*McDonnell Douglas  
Helicopter Company*

NOTICE NO. HN-66  
DATE 25 March 1974  
PAGE 1 OF 4

**SERVICE INFORMATION NOTICE**

SUBJECT: INSPECTION OF 369A2515-3 FRAME AND BATTERY

Figure 1. Fuselage Structure, Battery Location

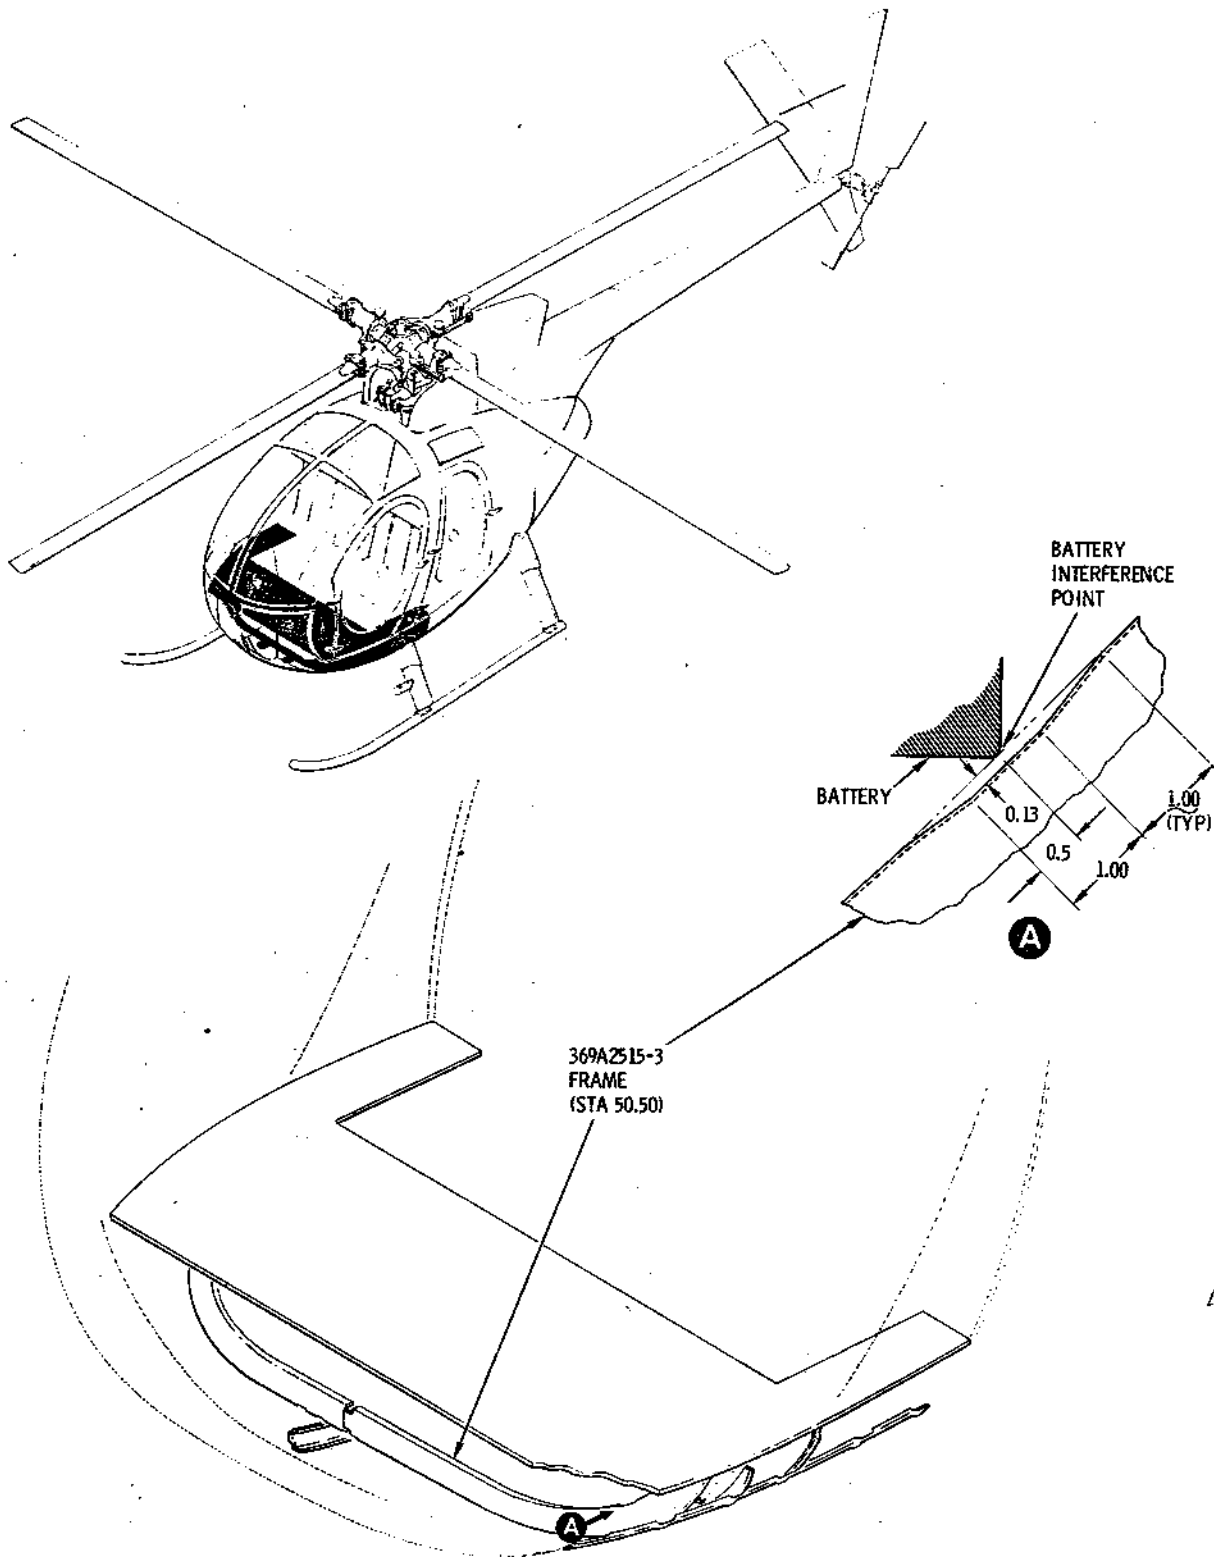
PREFACE: Instances of interference between the subject frame and the battery have been observed in the field.

This Service Information Notice provides procedures for a one-time inspection of the frame and corrective action should the interference exist.

- c. Re-install battery and secure battery compartment.
- d. Record compliance with this Service Information Notice in Compliance Record of Helicopter Log Book.
